Sub Regional RTEP Committee: Western Dayton Supplemental Projects

November 18, 2022

Changes to the Existing Projects

S2585 (.1-10) is posted in 2022 Dayton local plan to address Dayton supplemental Needs: Dayton-2020-011, Dayton-2021-001, Dayton-2021-008

➤ **AEP Hayes Substation & AEP Hayes- New Westville Interconnection**

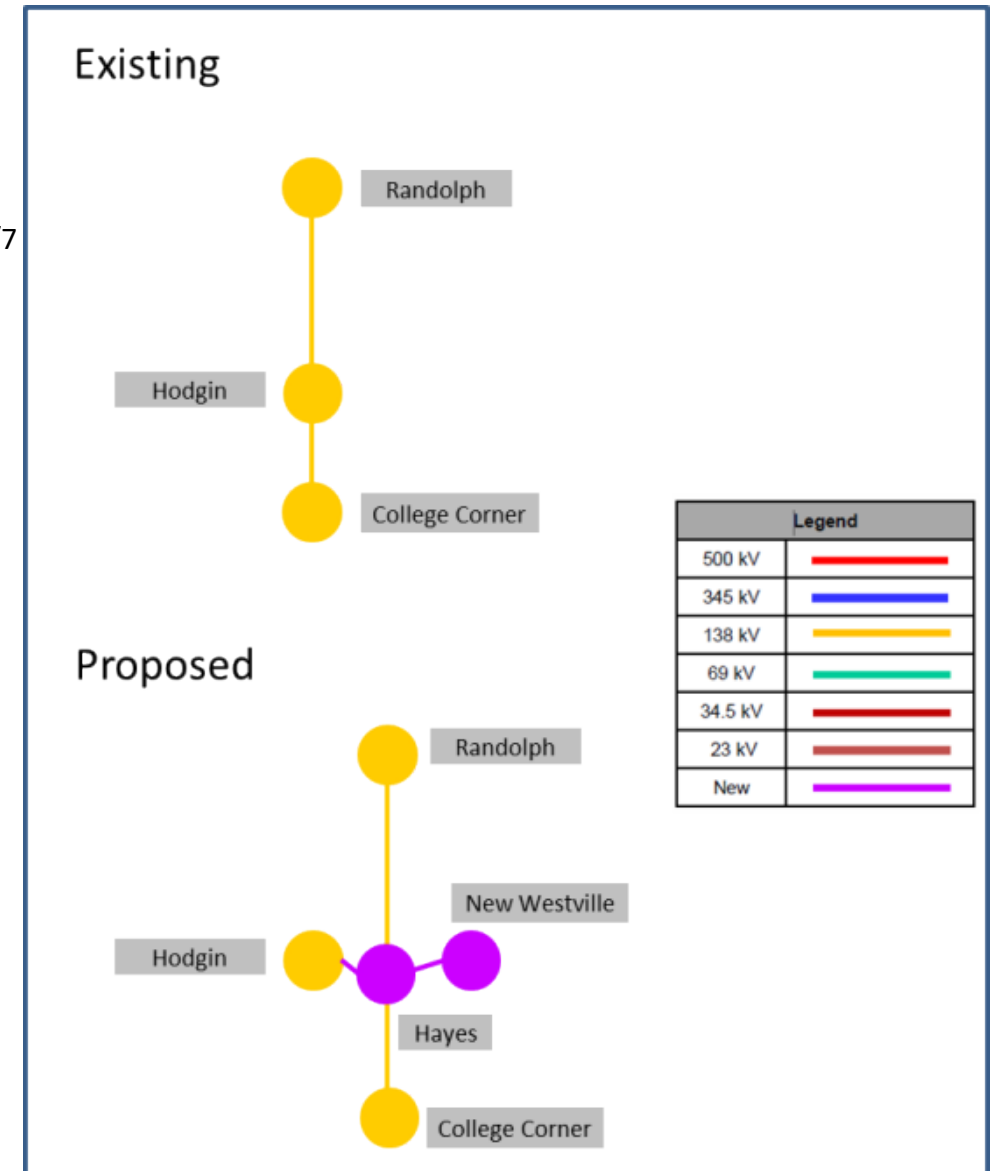
Additional Scope to Previous Solution:

- Hayes – New Westville 138 kV line: Build ~0.19 miles of 138 kV line to the Indiana/ Ohio State line to connect to AES’s line portion of the Hayes – New Westville 138 kV line with the conductor size 795 ACSR26/7 Drake. The following cost includes the line construction and ROW. **(s2585.11)**
- **Cost: \$0.38 M (AEP)**
- Hayes – Hodgin 138 kV line: Build ~0.05 miles of 138 kV line with the conductor size 795 ACSR26/7 Drake. The following cost includes the line construction, ROW, and fiber. **(s2585.12)**
- **Cost: \$ 1.22 M (AEP)**
- Hayes 138 kV: Build a new 4-138 kV circuit breaker ring bus. The following cost includes the new station construction, property purchase, metering, station fiber and the College Corner –Randolph 138 kV line connection. **(s2585.13)**
- **Cost: \$ 7.44 M (AEP)**
